SERVICE UPDATE

Subject: New Style Oil Pick Up

Models Affected: 2200, 2500, 2600, 2750, 2775, 2900, 3050, PP255, PP295, PP310, PP315, PP4620AV, PP4620AVHD, PP4620AVL

Below is a diagram of the new one piece pickup assembly.

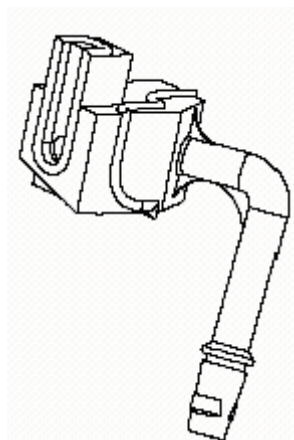
A new one piece oil pickup assembly has been introduced for the above models. The new part number is **545-047801**. This new part replaces part 530-037057.

The improved part will eliminate issues seen with these saws involving leakage, sporadic oiling and no oiling situations. Normal warranty will apply.

When replacing the pickup assembly, the oil seal 530-019174 will not be re-used and can be discarded.
